P&WC S.B. No. 41112R1

TURBOSHAFT ENGINE
FUEL MANAGEMENT MODULE (FMM) - REPLACEMENT/MODIFICATION OF

PT6C-67C, PT6C-67C1

SUBJECT: Pratt & Whitney Canada Service Bulletin No. PT6C-72-41112, Rev. No. 1, dated Jun 09/2021 (P&WC S.B. No. 41112R1) FUEL MANAGEMENT MODULE (FMM) - REPLACEMENT/MODIFICATION OF

Fuel Management Module - Parts Progression
Figure 1 (Sheet 1 of 2)

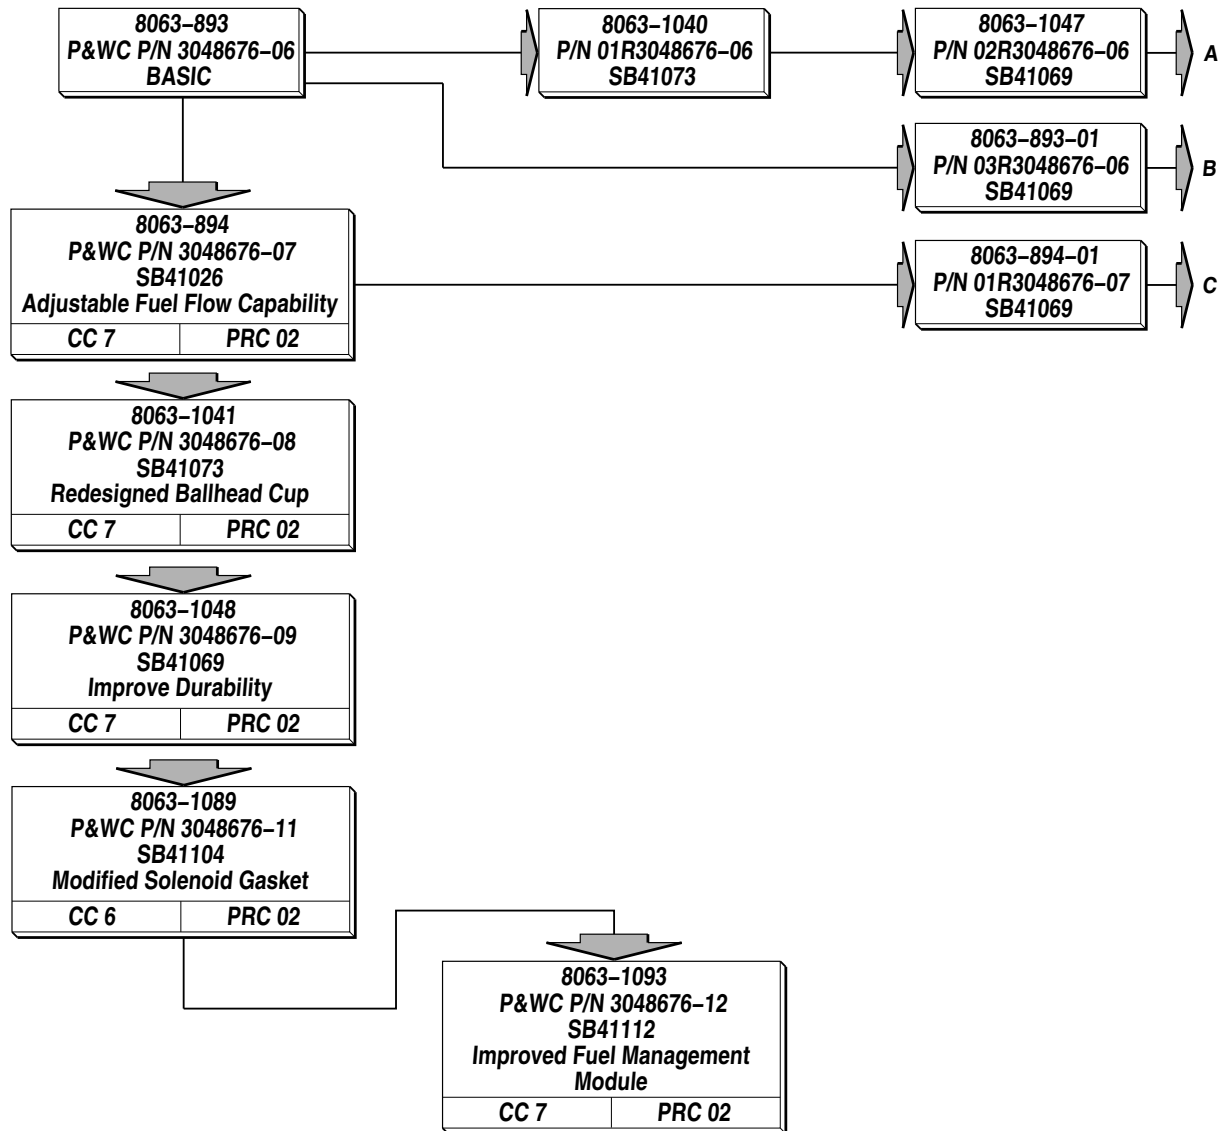
- A. Refer to Figure 1 for the parts progression.
